5-E-21-HZ
APPLICATION FOR CERTIFICATE OF APPROPRIATENESS

207 S. Seventeenth St. 37916
Ft. Sanders NC

Original Print Date: 5/5/2021
 Knoxville/Knox County Planning -- Historic Zoning Commission

Level III Demolition/Relocation of Noncontributing Structure, Construction of New Primary Building

A3.3

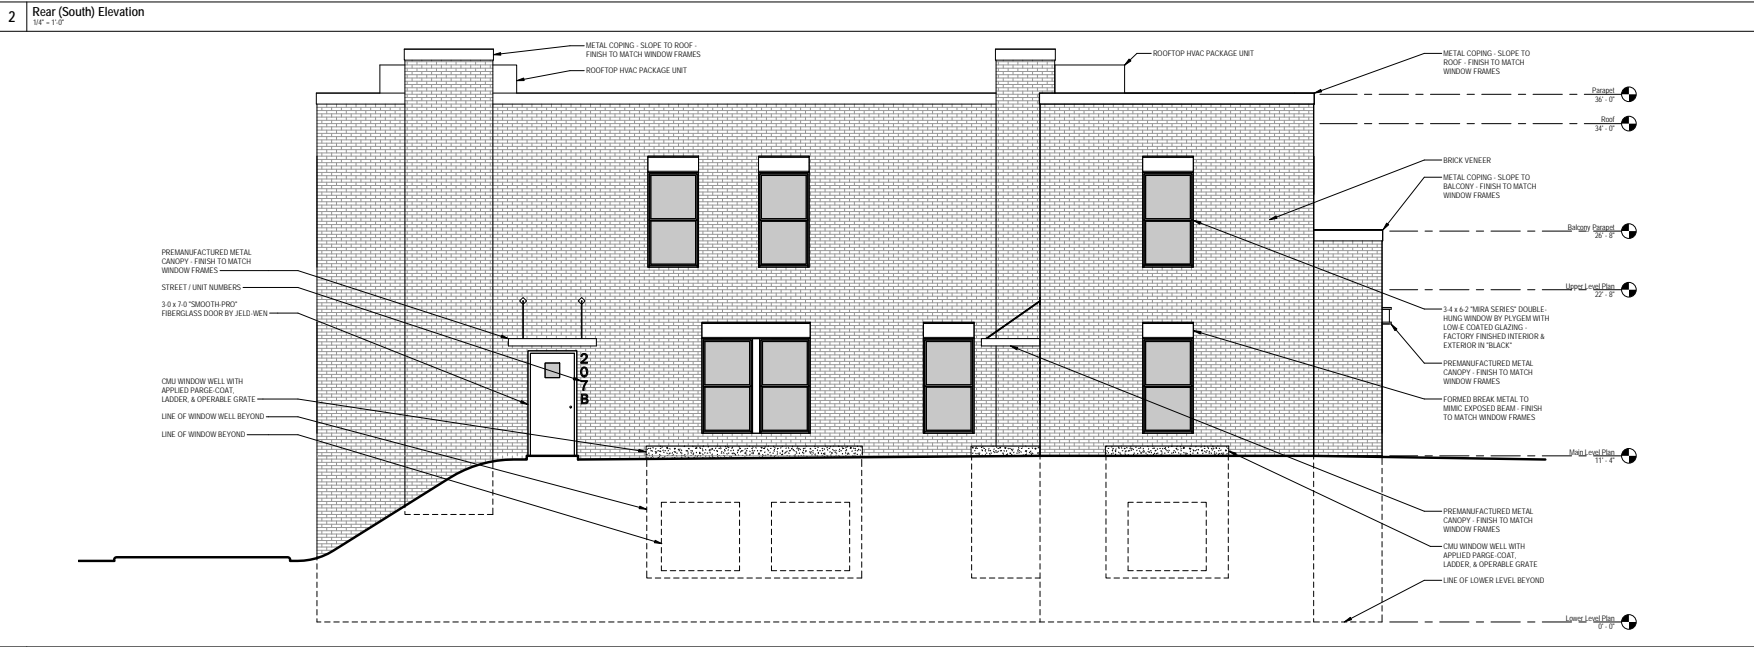
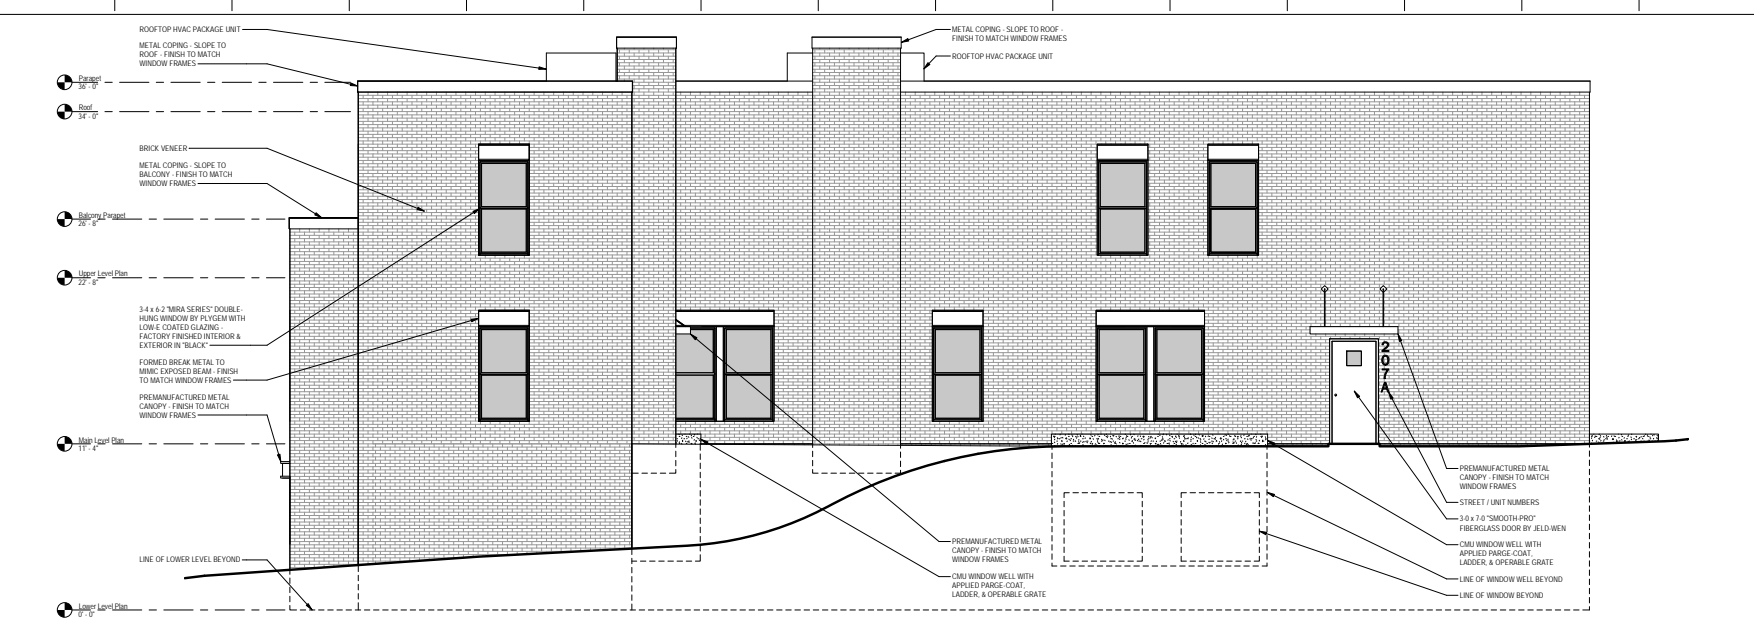
REAR ELEVATIONS: At the May 20, 2021 HZC meeting, application was approved with conditions identified by staff, with the additional condition that the rear elevation drawings be revised and return to the Commission for review. The applicant has provided revised rear elevation drawings. The L-shaped rear elevation features irregularly-spaced double-hung, aluminum-clad windows topped by anodized aluminum headers. Over each secondary entrance door is a flat roof, metal canopy, painted to match window frames and headers. Doors are 3' wide by 7' tall smooth-finished fiberglass doors with a single light. Metal roof coping extends around rear elevations, finished to match window frame colors.

1. Due to the building's L-shape and frontage facing Forest Avenue and S. Seventeenth Street, the rear elevations will be very minimally visible from the public right-of-way.

2. At the May 2021 HZC meeting, the Commission discussed the lack of ornament or additional decoration on the rear elevation, along with the somewhat irregular placement of windows. The revised proposal includes window headers to match the façade elevations, along with flat-roof metal canopies projecting outwards over the doors.

Seventeenth Street Elevation | Materials

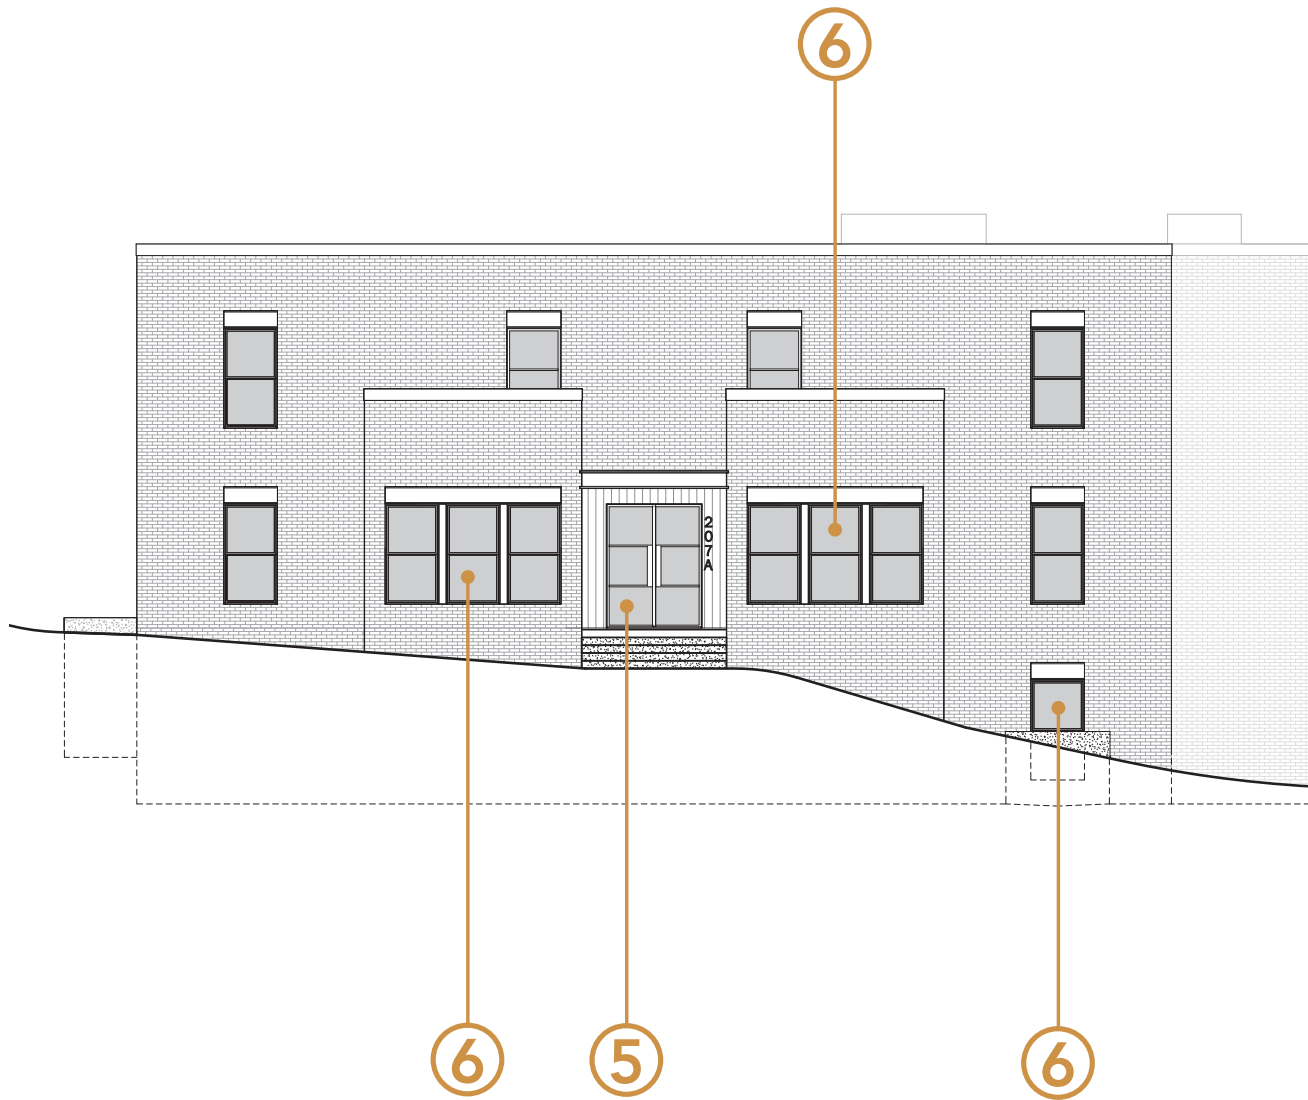
3. The proposed modular red brick veneer is appropriate for the new building and the selected style. The anodized aluminum window headers, coping in a corresponding color, and cedar ship-lap siding will complement the brick veneer.

4. In general, the window proportions and symmetry on the S. 17th Street and Forest Avenue elevations are compatible with historic window proportions in the neighborhood. The selected double-hung, aluminum-clad
